PUBLIC WORKS DEPARTMENT

0/0 THE SUPERINTENDING ENGINEER

Sub.: Inspection of various drain work under North Road Maintenance Division on 18.05.2020 at 11:00 a.m.

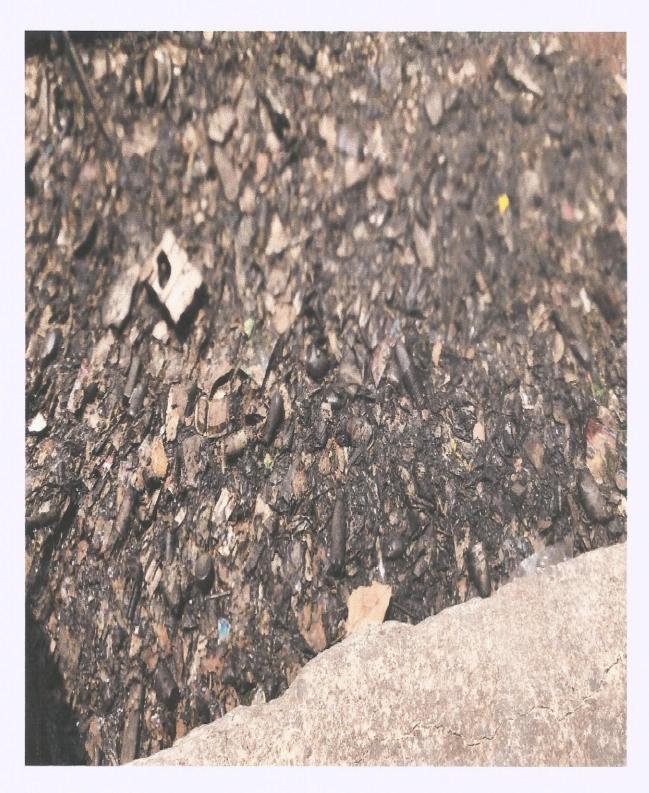
- 10. Regular removing of floating material may be carried out from time to time.
- 11. One chamber near main Jahangirpuri road is full of silt/floating material. Same may be cleaned immediately.

- 12. One bell mouth coming form service road to main drain was found chocked near metro pillar no. 132.
- 13. Some main holes/chambers of the Mall Road Extension drains needs further cleaning.

- 14. One chamber near Rajasthan Udhog Swiss Company is completely chocked which may be cleaned immediately.
- 15. One pothole on main road near Jahangirpuri Metor station on carriageway from Mukarba Chowk to Jahangirpuri metro station needs immediate repair.
